<b>DEVELOPMENT NO.:</b>	25017669
<b>APPLICANT:</b>	Tom Sagris
<b>ADDRESS:</b>	11A ESPLANADE SOMERTON PARK SA 5044
<b>NATURE OF DEVELOPMENT:</b>	Alterations and additions forward of existing dwelling and associated carports to side and rear of dwelling
<b>ZONING INFORMATION:</b>	<p><b>Zones:</b></p> <ul style="list-style-type: none"> <li>• Waterfront Neighbourhood</li> </ul> <p><b>Overlays:</b></p> <ul style="list-style-type: none"> <li>• Airport Building Heights (Regulated)</li> <li>• Affordable Housing</li> <li>• Building Near Airfields</li> <li>• Coastal Flooding</li> <li>• Prescribed Wells Area</li> <li>• Regulated and Significant Tree</li> <li>• Stormwater Management</li> <li>• Urban Tree Canopy</li> </ul> <p><b>Technical Numeric Variations (TNVs):</b></p> <ul style="list-style-type: none"> <li>• Finished Ground and Floor Levels (Minimum finished ground level is 3.2m AHD; Minimum finished floor level is 3.45m AHD)</li> <li>• Minimum Frontage (Minimum frontage for a detached dwelling is 5m; semi-detached dwelling is 5m; row dwelling is 5m; group dwelling is 5m; residential flat building is 5m)</li> <li>• Minimum Site Area (Minimum site area for a detached dwelling is 300 sqm; se

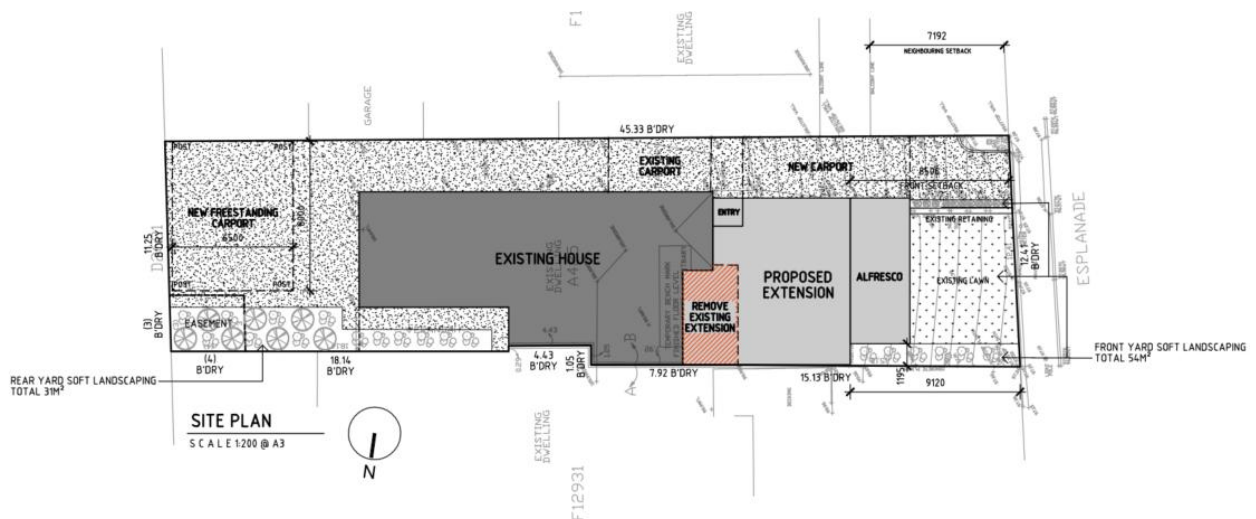
The front verandah is setback between 5.4 and 5.8 metres from the primary street boundary, which is 3.1 metres forward of the building facade, but presents an important function in enhancing the seaward outlook, whilst providing cover from the western summer sun. Design in Urban Areas,

Residential Development, Low Rise, External Appearance PO 22.2 suggests that porches or porticos project at least 1 metre forward from the building wall, therefore in context with this site having a direct outlook to the Esplanade, the 3.1-metre-deep verandah is a positive viewpoint with respect to achieving energy efficiency and good environmental outcomes where possible and reasonable.

Regarding the primary street setback, Designated Performance Feature 5.1 suggests a minimum setback of the average setback of neighbouring dwellings. In this case, it would be 12.3 metres, which is considered excessive in context with newer and emerging built form in the locality. Critically, the consideration of an appropriate primary street setback must have regard to the relevant Performance Outcome 5.1, which seeks building setbacks that contribute to the existing/emerging pattern of setbacks in the streetscape and waterfront environment. In the context of this site, the proposed primary setback is compatible with the emerging front setback pattern and streetscape, particularly in the case here where it is adjacent to older housing stock and comprises a single level-built form.

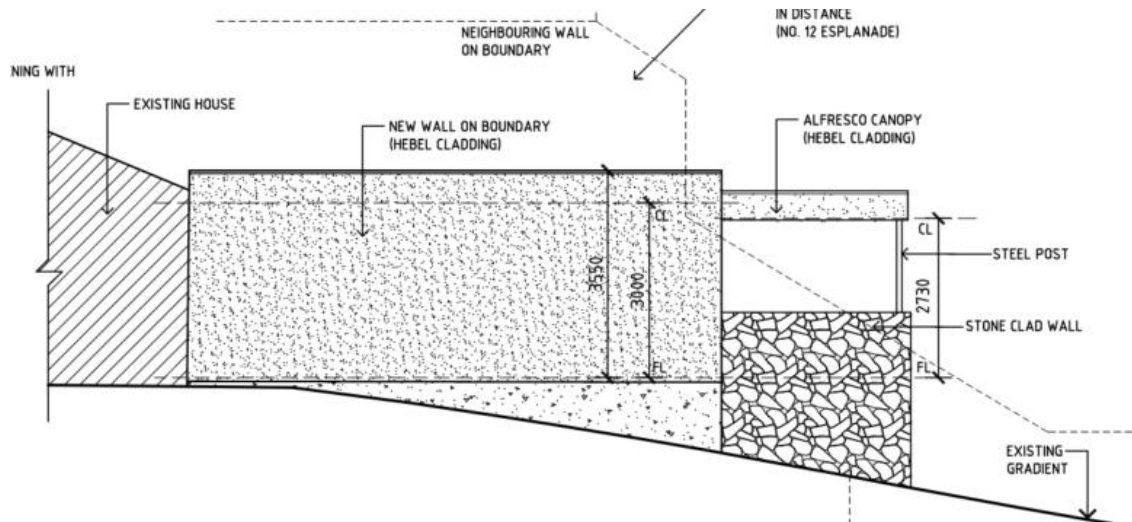
The building has a 3.5-metre-high wall (above the top of the footing) located on the northern side boundary. This comprises an addition of 9 metres to the existing boundary wall length of 5 metres, for a total boundary wall length of 14 metres.

The boundary wall height of 3.5 metres above the footing, on balance, is satisfactory, as the wall is on the northern side boundary, so does not present an overshadowing impact. Visually, the wall is relatively high from the northern neighbour's perspective. However, in context with the natural slope of the land, the build-up of the neighbour's deck and verandah that abut the addition, and the fact the wall does not cast a shadow on the northern neighbour, the overall wall height relative to natural ground level is acceptable.

The boundary wall is considered to satisfy the Zone Performance Outcome 7.1, in that the wall on the boundary is limited in height and length to manage visual and overshadowing impacts on adjoining neighbours. It extends approximately 1 metre forward of the neighbour's front deck and verandah, effectively closing that side in. While this results in the loss of some views to the southwest, it does provide some privacy and added protection from the prevailing south-westerly winds. Furthermore, this neighbour did not submit a representation objecting to the proposed development.

The impacts on the southern neighbour are relatively minor. That three-level dwelling has large walls on the common boundary, tapering down to the front. A portion of the proposed carport level with the proposed alfresco will be above the tapered wall, but predominantly open with negligible impacts relative to the scale of that dwelling.

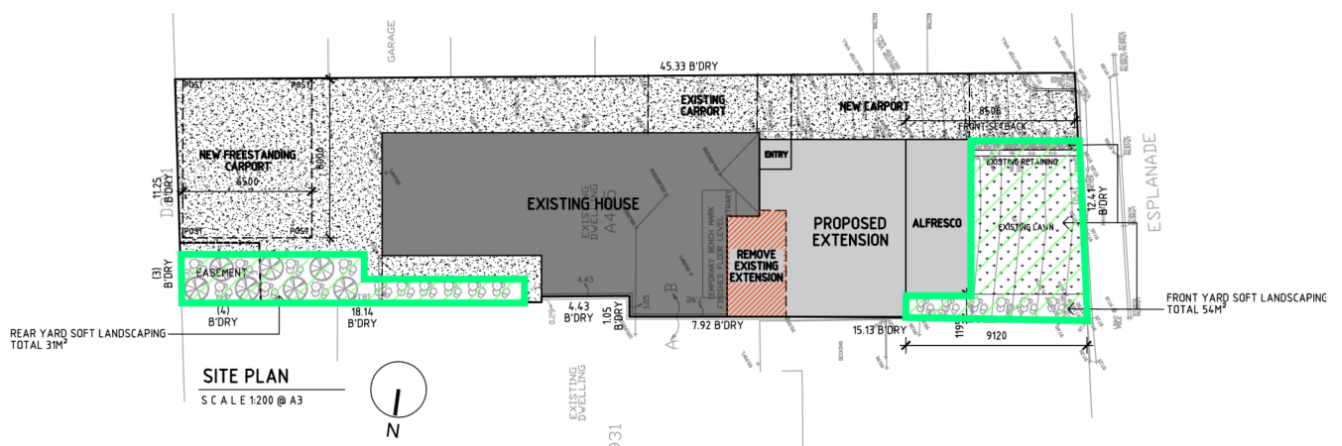
The site currently has soft landscaping amounting to 14 percent of the site area. The proposed development will result in soft landscaping amounting to 16 percent of the site area, which is a 2 percent net gain. This satisfies Performance Outcome 6.1 in that the development incorporates landscaping to minimise heat absorption and reflection, provides for stormwater infiltration and biodiversity, and enhances the appearance of land and streetscapes.

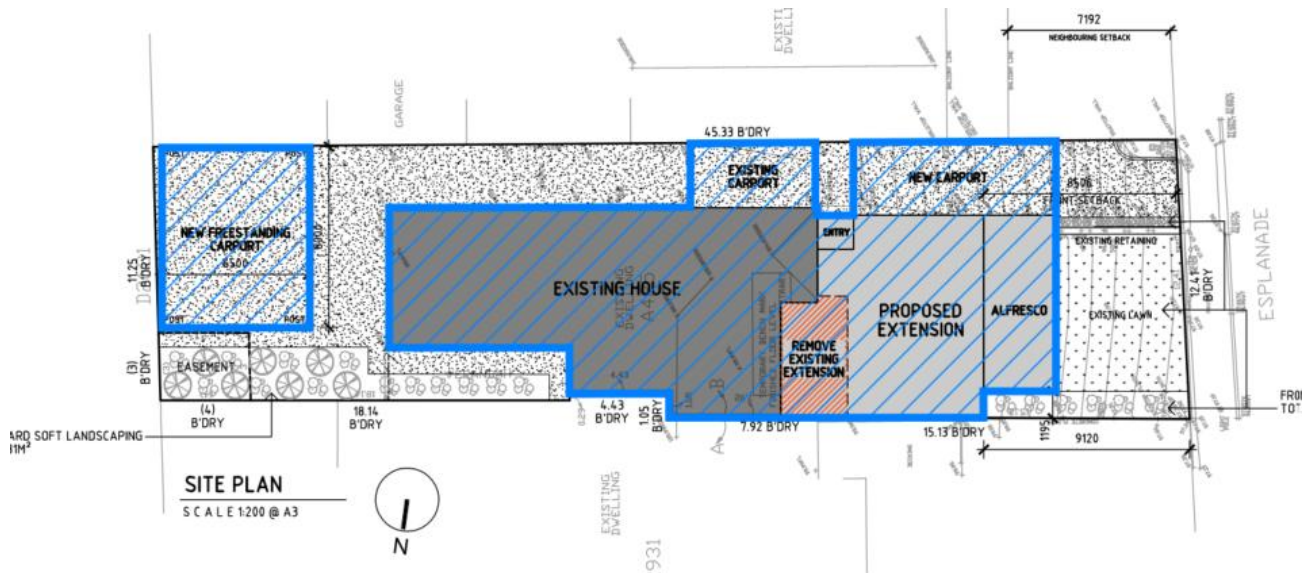
Site coverage amounts to 61 percent of the site area. This only slightly exceeds the 60% suggested by Zone DPF 3.1 and satisfies Performance Outcome 3.1 in that it allows for sufficient space around buildings to limit visual impact, provide an attractive outlook, and ensure access to natural light and ventilation.
